# HISTORIC AND DESIGN REVIEW COMMISSION

February 17, 2021

**HDRC CASE NO:** 2021-033  
**ADDRESS:** 324 E ROSEWOOD AVE  
**LEGAL DESCRIPTION:** NCB 6728 BLK 4 LOT 38 39 & 40, W 4 FT OF 41 -C  
**ZONING:** RM-4, H  
**CITY COUNCIL DIST.:** 1  
**DISTRICT:** Monte Vista Historic District  
**APPLICANT:** Matt Bishop/BEXAR DIVERSIFIED MF-1 LLC  
**OWNER:** Matt Bishop/BEXAR DIVERSIFIED MF-1 LLC  
**TYPE OF WORK:** Roof replacement  
**APPLICATION RECEIVED:** January 07, 2021  
**60-DAY REVIEW:** Not applicable due to City Council Emergency Orders  
**CASE MANAGER:** Rachel Rettaliata

The applicant is requesting a Certificate of Appropriateness for approval to replace the existing tile roof with a composition shingle roof.

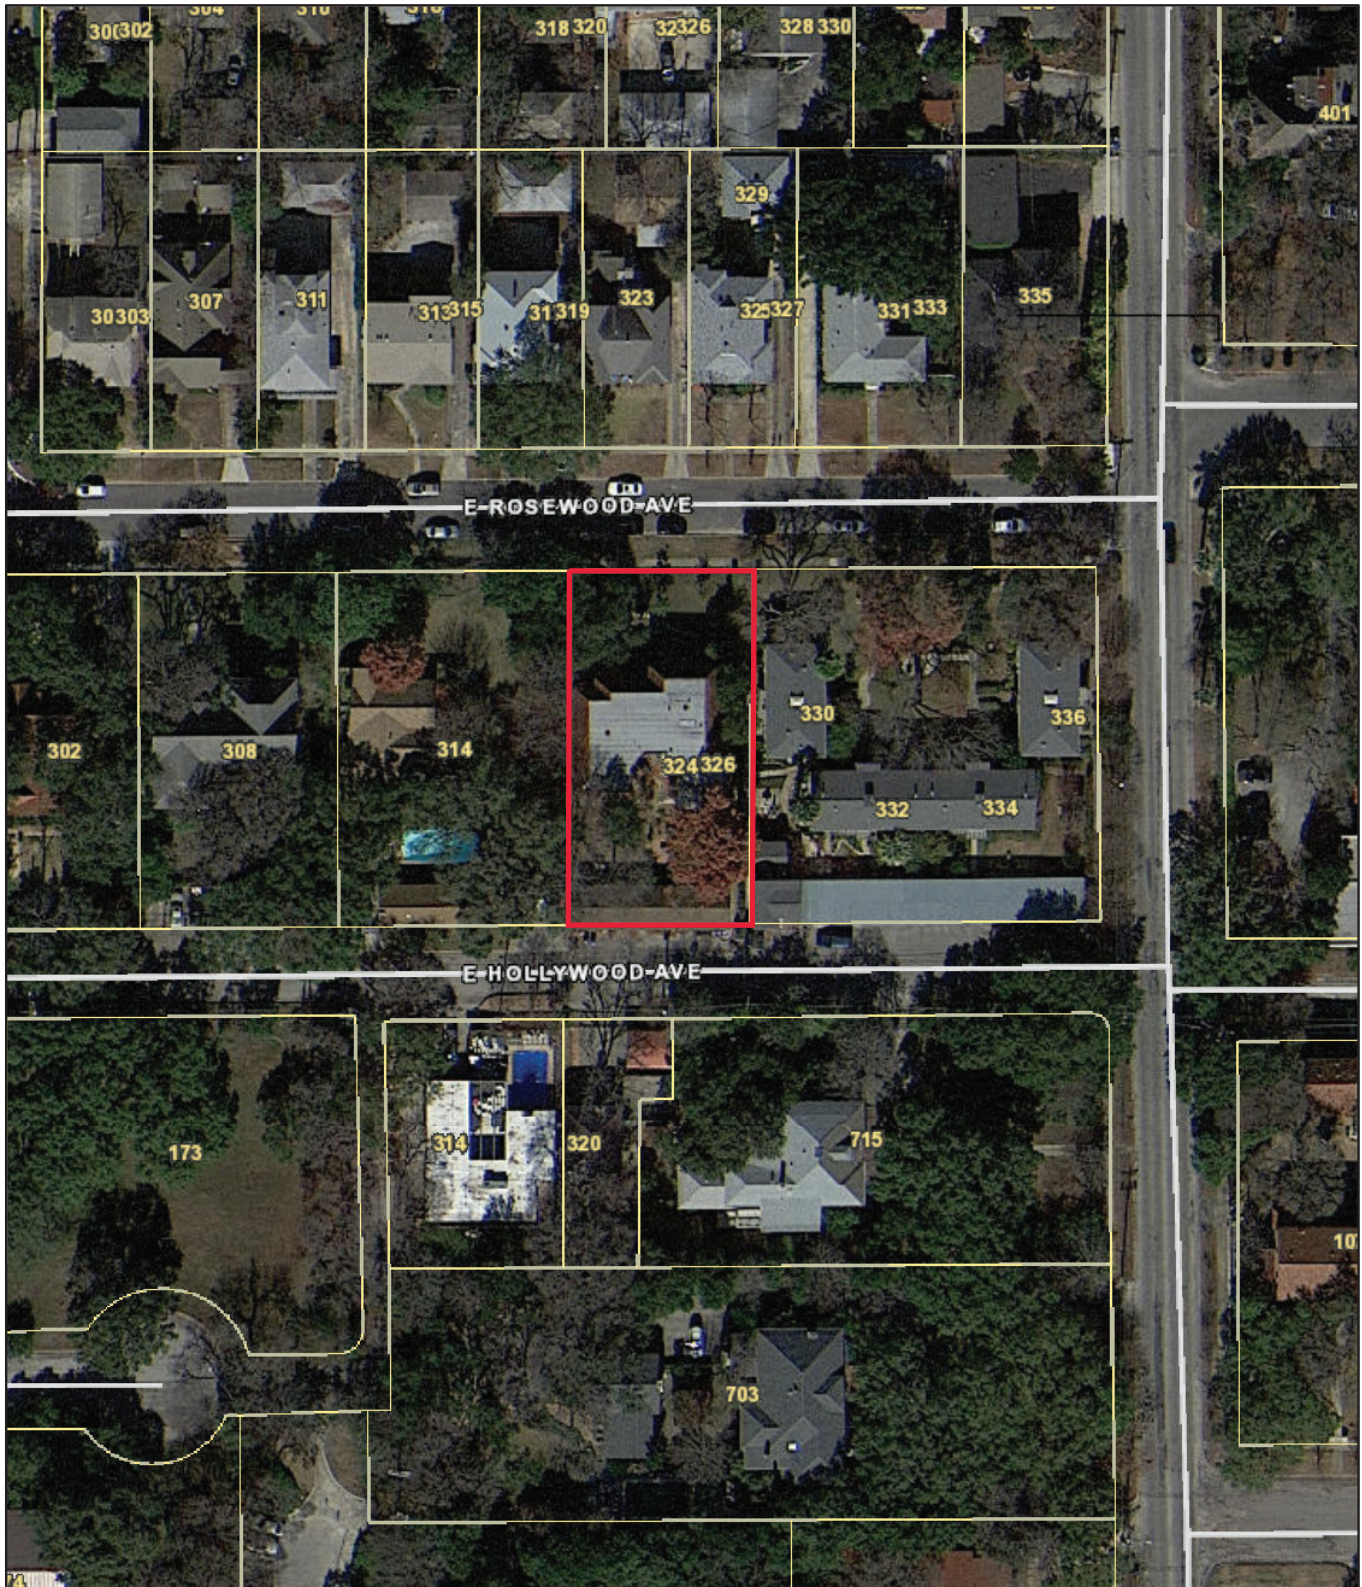
- a. The primary structure located at 324 E Rosewood is a 2-story, multi-family structure constructed circa 1930. It first appears on the 1951 Sanborn map. The structure has an asymmetrical u-shape plan and features a flat roof with mansard slopes and red clay or ceramic tiles, a pitched tile porch roof, a secondary front gable porch awning, a stone veneer, and one-over-one windows. The property is contributing to the Monte Vista Historic District.

- b. The applicant has proposed to replace the existing red clay or ceramic tile roof with a composition shingle roof to match other stone veneer properties on the block. Guideline 3.B.iv for Exterior Maintenance and Alterations states that roofing materials should be replaced with in-kind materials whenever possible when the roof must be replaced. Historic materials such as slate or clay tiles should be retained and re-used when large-scale replacement of roof materials other than asphalt shingles is required. The existing clay roof tiles are severely damaged and require replacement. Furthermore, Guideline 3.B.iv states that new roofing materials should match the original materials in terms of their scale, color, texture, profile and style or materials should be selected that are consistent with the building style when in-kind replacement is not possible. The 1951 Sanborn map shows that the original roof was composition; however, the Sanborn map may have referenced the material of the flat roof portion of the structure. Staff finds the request is inconsistent with the Guidelines. Staff finds that the installation of a material, such as pressed metal, that is similar in appearance to the existing tile would be appropriate.

Staff does not recommend approval based on findings a through b. Staff recommends that the roof is replaced with in-kind materials or a material similar in appearance to the existing tile.

- i. That the replacement composition shingles are similar in appearance to the existing tile and are verified by staff. The applicant is required to submit final material specifications to staff for review and approval.
- ii. That the applicant maintains the existing ridge detailing.
